Device	C164CI-8R, C164SI-8R, C164CL-8R, C164SL-8R, C164xy-L
Marking/Step	(E)ES-CA, CA, CA+
Package	P-MQFP-80

This Errata Sheet describes the deviations from the current user documentation.

Figure 1 Critical Event

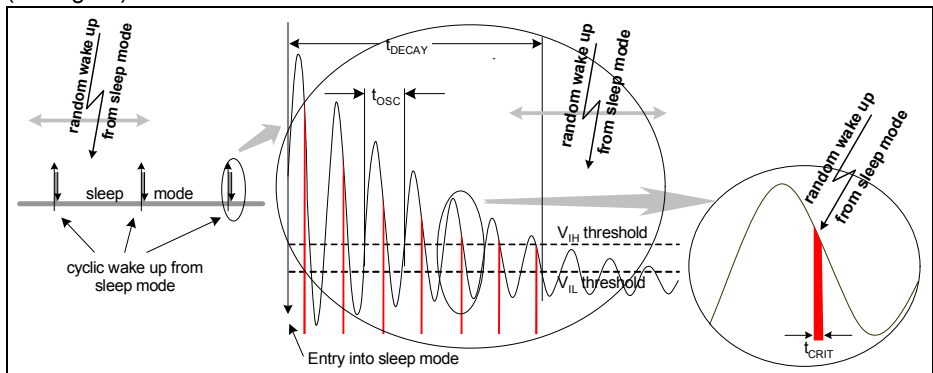
POWER.22 Wake up from Sleep Mode in Oscillator Decay Time

Due to a synchronization problem, the device may not correctly wake up from sleep mode if an asynchronous external wake up trigger occurs already in the oscillator decay time, i.e. in a particular time window before the device has actually entered sleep mode (see figure)

3. the external wake up trigger signal (fast external interrupt or signal on pin $\overline{\text{NMI}}$) coincides with the critical time window (t_{CRIT}) of each oscillator cycle during the decay time of the clock signal at pin XTAL1 (critical times shown in red in figure)

The problem occurs only in the decay time of the main oscillator and in a very small window around the clock edge at XTAL1 (t_{CRIT} is about 5 ps wide).

Workarounds:

- Select RTC on in sleep mode (SYSCON1.SLEEPCON = 01_B).
For devices with auxiliary oscillator (e.g. C161CS), select main oscillator as clock source (SYSCON2.RCS = 0).
- Avoid a wake up during the main oscillator decay time

Figure 2 SSCTB Timing

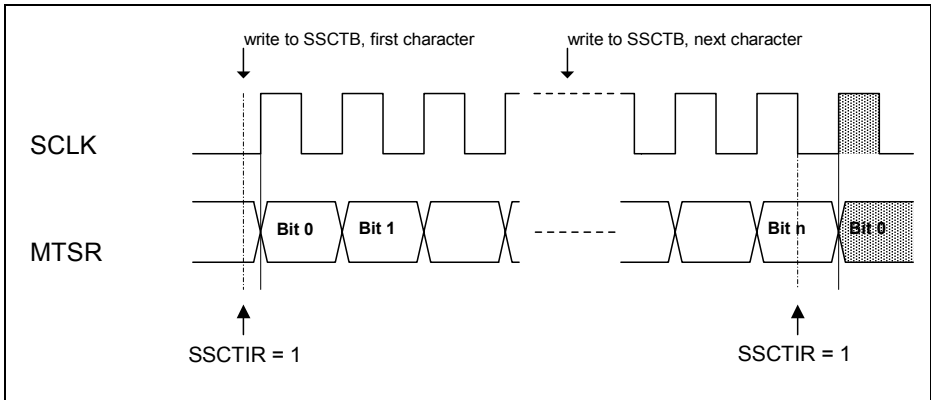
SSC.H2 Timing of flag SSCTIR (SSC Transmit Interrupt Request)

When SSCTB has been written while the transmit shift register was empty (and the SSC is enabled), flag SSCTIR is set to '1' directly after completion of the write operation, independent of the selected baud rate. When the transmit shift register is not empty when SSCTB was written, SSCTIR is set to '1' after the last latching edge of SCLK (= 1/2 bit time before the first shifting edge of the next character). See also e.g. C167CR User's Manual V3.1, p. 12-5.

The following diagram shows these relations in an example for a data transfer in master mode with SSCPO = 0 and SSCPH = 0. It is assumed that the transmit shift register is empty at the time the first character is written to SSCTB:

Typically, in interrupt driven systems, no problems are expected from the modified timing of flag SSCTIR. However, when flag SSCTIR is polled by software in combination with other flags which are set/cleared at the end or at the beginning of a transfer (e.g. SSCBSY), the modified timing may have an effect.

In order to achieve a defined and systematic behavior with all device steps, the SSC receive interrupt, which is generated at the end of a character transmission, may be used instead of the SSC transmit interrupt.

Figure 3 Reset Configuration Source Selection

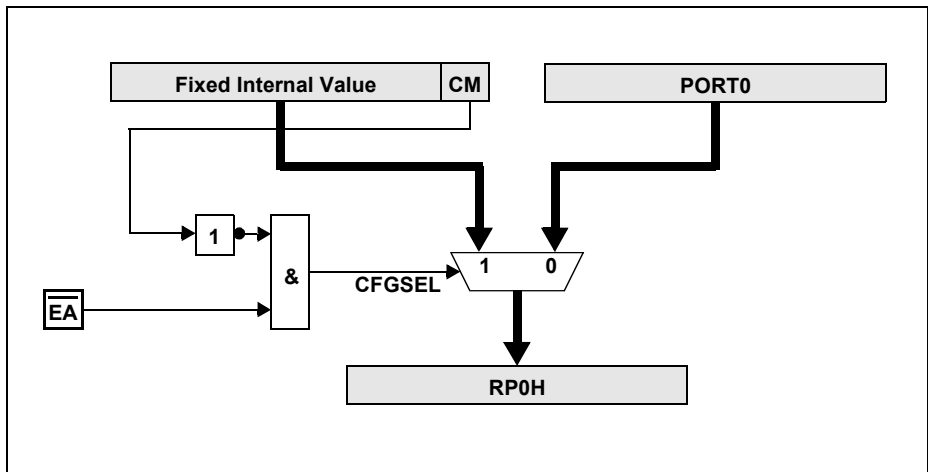
In contrast to the user's manual in the C164CI-8R the register RSTCON is not available. After single-chip mode reset the register RP0H is not set to the described default value but shows the configuration defined in the ROM mask (Configuration Byte) as follows.

For a single-chip mode reset (indicated by $\overline{EA} = 1$) the configuration via PORT0 can be replaced by a fixed configuration value. This fixed configuration value is hardwired and is selectable for each ROM mask. In this case PORT0 needs no external circuitry (pullups/pulldowns) and also the internal configuration pullups are not activated.

The logic described in the figure above controls the reset configuration source (see signal CFGSEL) in the following way:

Figure 4 Internal Reset Configuration Byte

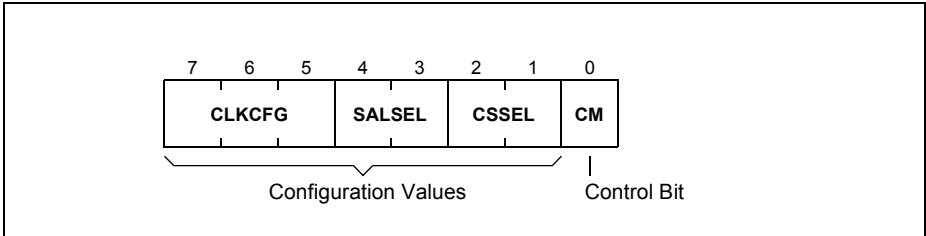
The fixed internal value and the compatibility mode control bit CM for the Single-Chip reset are specified by a byte value described below. This byte value shall be stored at location 00'003E_H within the user ROM code.
